PLAYGROUND SAFETY INSPECTION

PUMA PARK PLAYGROUND  
TRURO, MA

INSPECTED NOVEMBER 28, 2017

INSPECTED BY LEE ARCHIN, CPSI, & MICHAEL COHEN

### General Structure

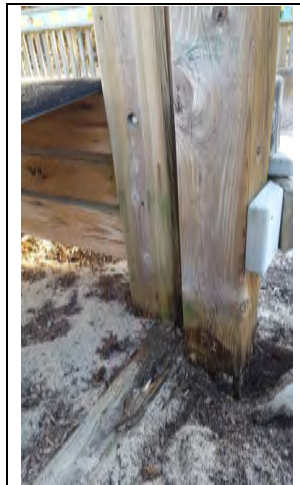
The structure is built using pressure-treated wood for the vertical posts and framing. The decking, most guardrails and barriers are Trex.

Substantial rot and decay was found in a few of the 6x6 posts. This rot was always at or below finished grade (i.e., the top of the safety surfacing). Note that we did not excavate to expose the posts below what was visible. We did not observe any posts that appeared structurally unsound where failure was at all imminent

Above grade, most of the posts have dried and show longitudinal splits/checks.

The tops of the 6 x 6 posts were all capped with plastic tops or otherwise covered (e.g., by platforms) and so there was no decay of the end-grain.

Expose and check all the posts below grade. If structurally sound, the decayed posts can be repaired.

Depending on the position of the posts, some decayed posts can be replaced entirely. We recommend using structural plastic posts for this.

Posts that are sound and have minimal or no decay should at least be thoroughly treated with a wood preservative and sealed.

For the worse posts that cannot easily be replaced, we recommend using a wood restoration product<sup>1</sup> to stabilize and repair the decay. Note, the same products can often be used also to fill longitudinal cracks.

Before installing any poured-in-place rubber safety surfacing, it is important to ensure all the posts at and below grade are stable. Once the rubber is in place you will not have access to the bottom of the posts. Therefore, in addition to the repairs outlined above, we recommend wrapping the base of all the posts with structural plastic lumber (1x6 or 2x6) to ensure the rubber has a stable boundary.

Posts thus repaired will still require maintenance to preserve their appearance and stability. It is important to keep the posts well sanded and re-sealed once a year.
